SUBJECT: ISSUANCE OF AMENDMENT NO. 50 TO FACILITY OPERATING LICENSE  
NO. NPF-63 REGARDING REACTOR COOLANT SYSTEM FLOW RATE - SHEARON  
HARRIS NUCLEAR POWER PLANT, UNIT 1 (TAC NO. M89450)

Amendment No. 50  
License No. NPF-63

SAFETY EVALUATION BY THE OFFICE OF NUCLEAR REACTOR REGULATION  
RELATED TO AMENDMENT NO. 50 TO FACILITY OPERATING LICENSE NO. NPF-63

FIGURE 2.1-1  
 REACTOR CORE SAFETY LIMITS - THREE LOOPS IN OPERATION  
 WITH MEASURED RCS FLOW  $\geq [293,540 \text{ GPM} \times (1.0 + C_1)]$

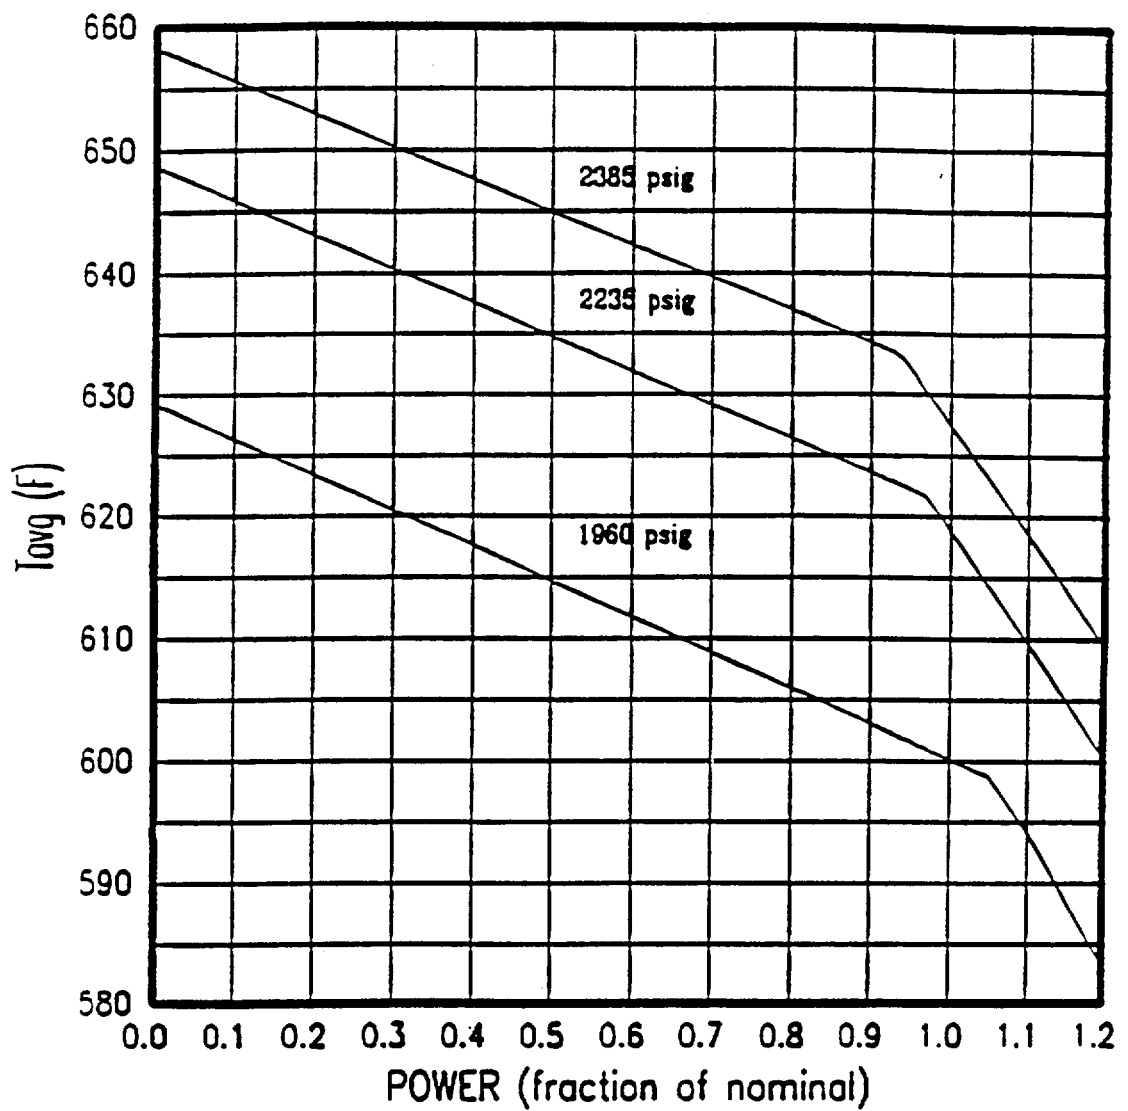
NOTE 7: This value is associated with measured RCS flow  $\geq [293,540 \text{ gpm} \times (1.0 + C_1)]$ . Technical Specification 3/4.2.3 requires this setpoint to be reduced at the rate of 1.5% of RTP for each 1% that measured RCS flow is below  $[293,540 \text{ gpm} \times (1.0 + C_1)]$ .

Figure 3.2-3

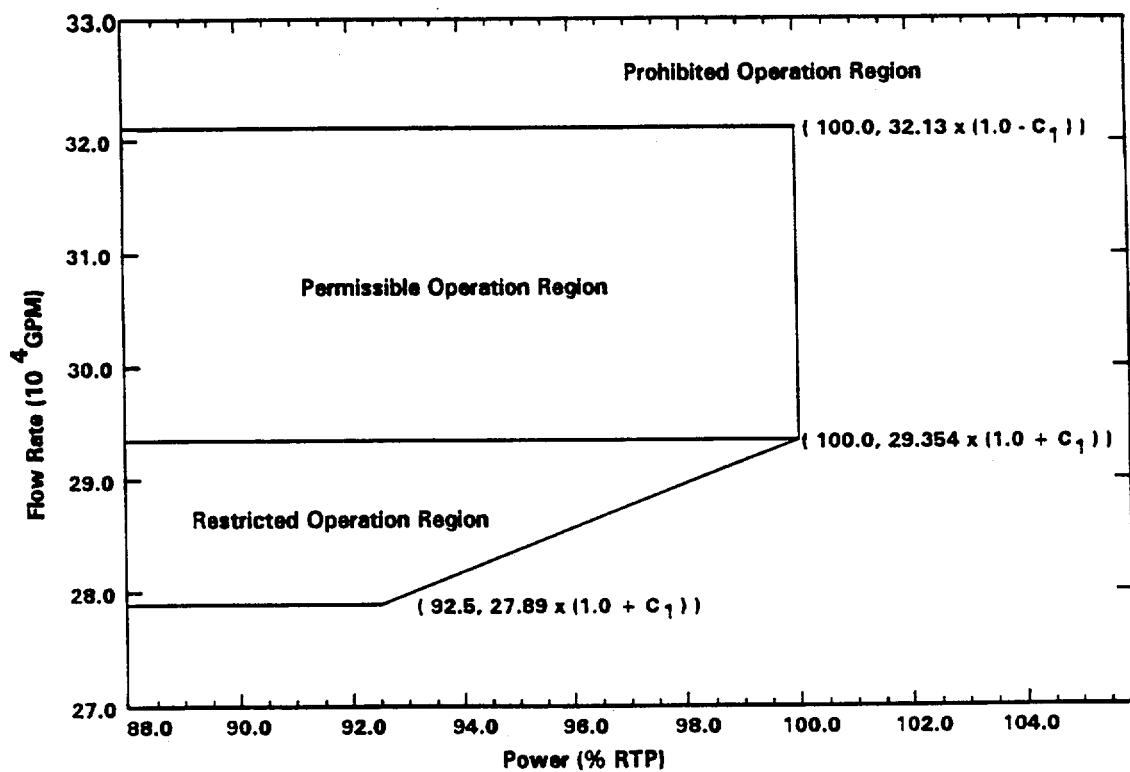
3.2.3 The combination of indicated Reactor Coolant System (RCS) total flow rate and THERMAL POWER shall be maintained within the region of permissible operation shown on Figure 3.2-3 for three loop operation and  $F_{\Delta H}$  shall be maintained as follows:

4.2.3.3 The RCS total flow rate shall be verified to be within the regions of restricted or permissible operation of Figure 3.2-3:

For the FSAR Chapter 15 analyses reliant on the Power Range Neutron Flux - High Trip Setting trip function, reduction of the Setpoint by the same percentage as the required power reduction in Figure 3.2-3 (1.5% RTP per 1% RCS flow rate) ensures DNBR margin is maintained. When in the region of restricted operation, defining  $\Delta T_0$  as the equivalent  $\Delta T$  at 100% RTP and  $[293,540 \text{ gpm} \times (1.0 + C_1)]$  (which includes measurement uncertainty for core flow) results in an effective OTAT setpoint reduction and maintains DNBR margins for those analyses reliant upon the OTAT trip. The additional restrictions on  $F_{\Delta H}$  when in the region of restricted operation ensure that the margins gained by the power and setpoint reductions are not reduced by the normally allowable increases in radial peaking at reduced power levels.

The upper limit on measured RCS flow rate in Figure 3.2-3 [ $321,300 \text{ gpm} \times (1.0 - C_1)$ ] protects the mechanical design flow of 321,300 gpm per FSAR Table 5.1.0-1.

Power operation with reduced flow requires a corresponding reduction in power and lowering of the power range neutron flux high trip setpoint. Analyses performed by the Siemens Power Corporation indicates that the 1.5 percent power to 1.0 percent flow ratio along with the same reduction of the power

range neutron flux high trip setpoint, ensures that the minimum departure from nucleate boiling ratio (MDNBR) margin is maintained for those events which utilize the power range neutron flux high trip setpoint function. This power/flow reduction also maintains the enthalpy rise hot channel factor ( $F_{AH}$ ) at a value which is less than or equal to the value at 100 percent rated thermal power including measurement uncertainty.

In summary, the staff finds that the proposed TS changes that specify reduction of 1.5 percent of rated thermal power for every 1.0 percent of estimated flow below the minimum required flow for the rated thermal power will maintain the MDNBR and  $F_{AH}$  margins for events which rely on power range neutron flux high power trip or an OT $\Delta$ T trip. Therefore, the proposed changes are acceptable.
